SAN ONOFRE NUCLEAR GENERATING STATION, UNIT 2

AMENDMENT TO FACILITY OPERATING LICENSE

Amendment No. 4
License No. NPF-10

AMENDMENT TO LICENSE AMENDMENT NO. 4

Figure 6.2-2 Unit Organization, San Onofre Nuclear Generating Station-Unit 2

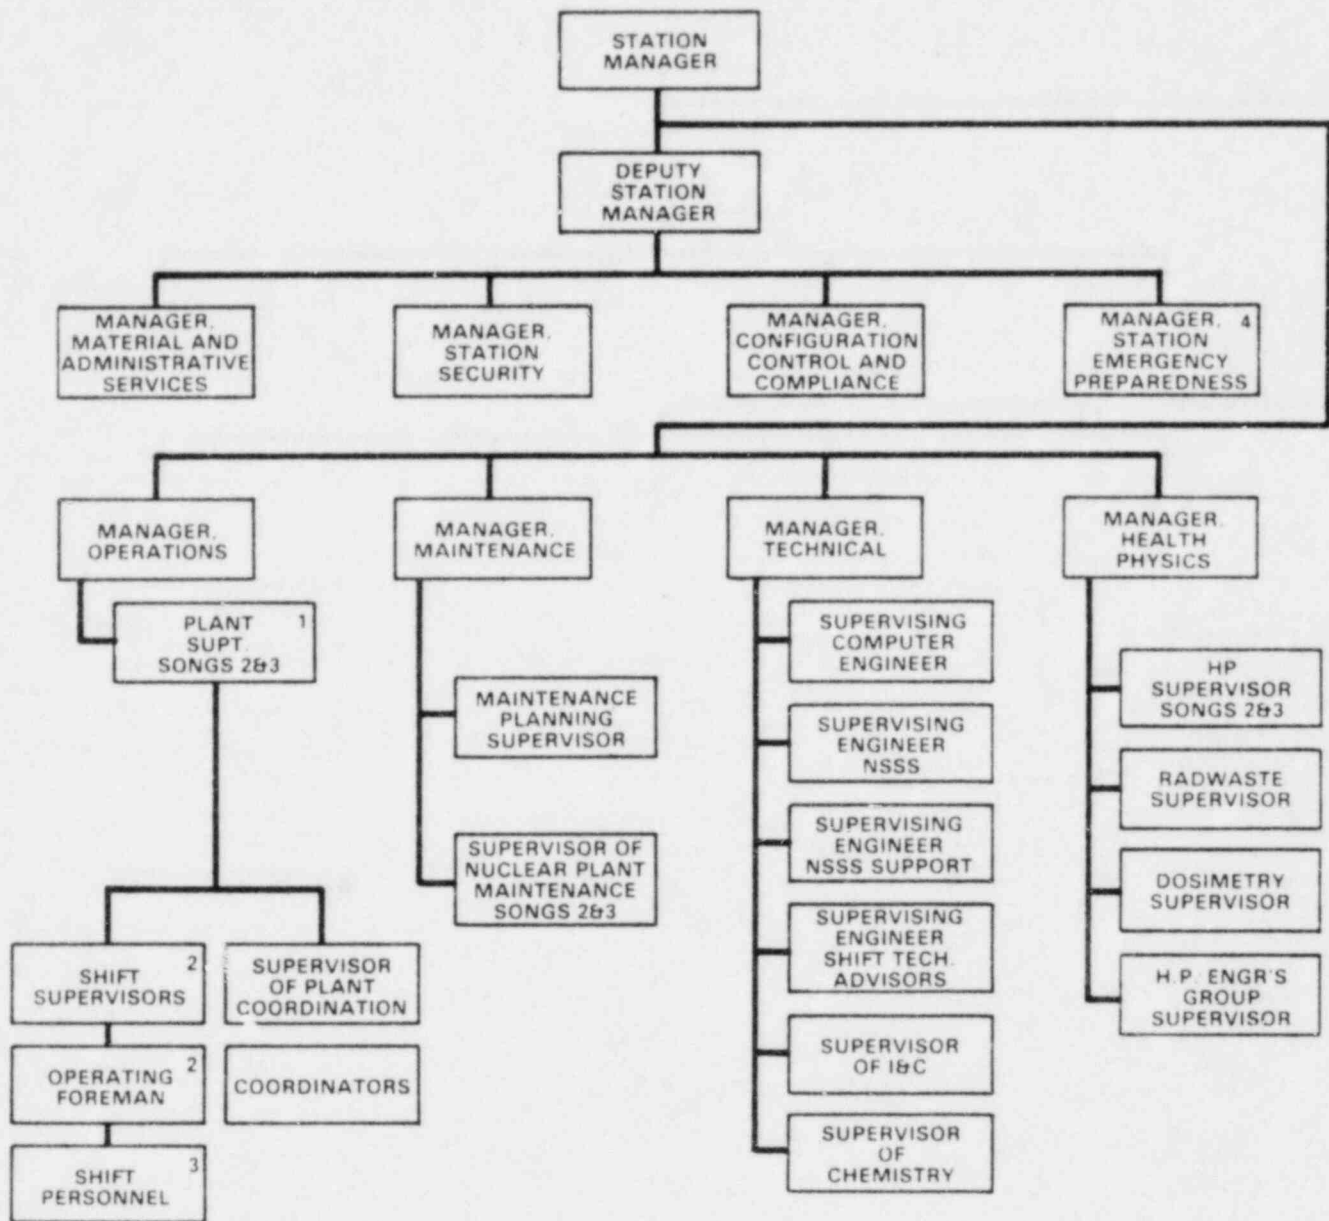
Change Technical Specification S 6.1-2, 6.2-2, Table 6.2-1, Figure 6.2-2 and Figure 6.2-3 to reflect current personnel titles.

The proposed changes to Figure 6.2-2 are primarily changes in position titles, as is suggested by the Licensee's description of the change. The inclusion of note 4 merely clarifies the fact that the Manager, Station Emergency Preparedness, is responsible for plant fire protection. There is no safety significance in these changes or in the deletion of the administrative position of Supervisor, Planning and Budgeting, under the Deputy Station Manager. Therefore, these changes are acceptable.
